**DATE:** January 6; 10:00 am – 11:00 am

**WORK IN PROGRESS:** Cutting out of existing mortar joints for repointing; removal of non-original stone at cheek walls; removal of stone specified to be replaced

**NOTES/OBSERVATIONS:**

Photo #7: The stones on the west jamb require replacement. (Photo by Mountain Masonry)

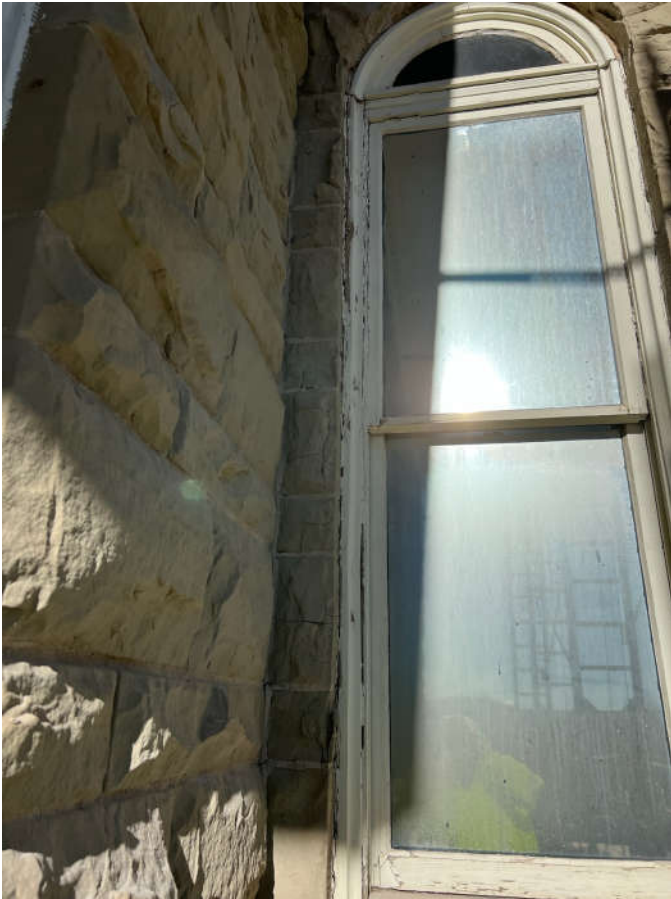
3. One of the masons noted that stones on the west jamb of the second floor window on the south tower wall are deteriorated. These stones were not called out on the drawings to be replaced but it was agreed that they should be as part of this project. (Re: Photo #7.)
4. The condition of the stones below the first floor window on the south wall of the tower was reviewed because the documents call for all of the stones at the infilled opening to be refaced; Dan thought one

Photo #8: The stones below the window at the infilled opening are specified to be replaced.

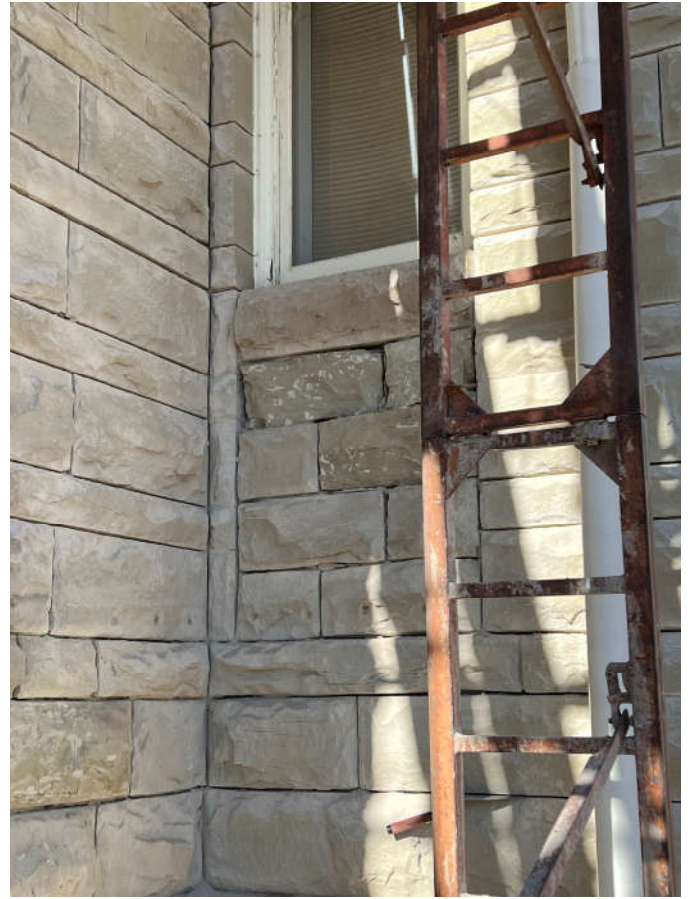
or two of the stones could possibly be salvaged. Following review, it was decided to reface all of the stones as called for on the drawings. (Re: Photo #8.)
